Service Letter #: SL08-35A-45065 Shear Bolt

Part/Assembly #: 35A-45000 3400 Main Gear, replacement of 35A-45050 Shear Pins with newly available 35A-45065 Shear Bolts.

Float Model/Aircraft Affected: Aerocet Model 3400 Amphibious Floats, Serial #330 and later, and any earlier floats in which cotter style shear pins have been replaced with the retaining ring style. (35A-45050, I/R is cotter pin style, while 35A-45050, Rev A is retaining ring style.)

(See Sheet 2 for Installation Illustrations)

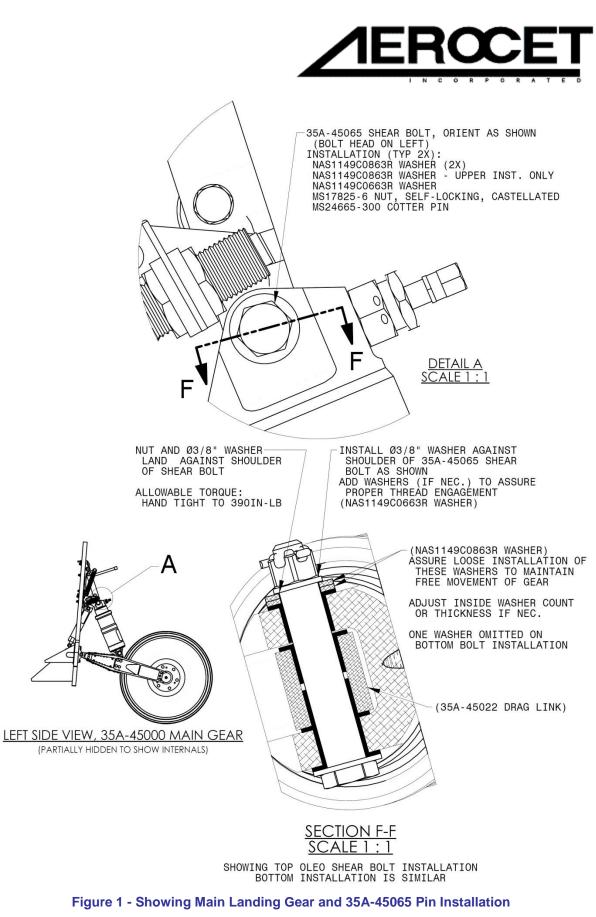
Symptom: MS16624-4050 Retaining Ring yielded due to over-spreading on installation.

It has been discovered that mechanics have overstretched the retaining rings that hold these pins in place upon either installation or removal of the shock strut reducing their retaining ability. As a result, retaining of the shock strut connecting pins may be lost.

Replace 35A-45050 Shear Pins with 35A-45065 Shear Bolts, as illustrated on following sheet.

- 1) 35A-45065 Shear Bolt (4X)
- 2) NAS1149C0863R WASHER (10X)
- 3) NAS1149C0663 WASHER (4X)
- 4) MS17825-6 NUT, SELF-LOCKING, CASTELLATED (4X)
- 5) MS24665-300 COTTER PIN (4X)
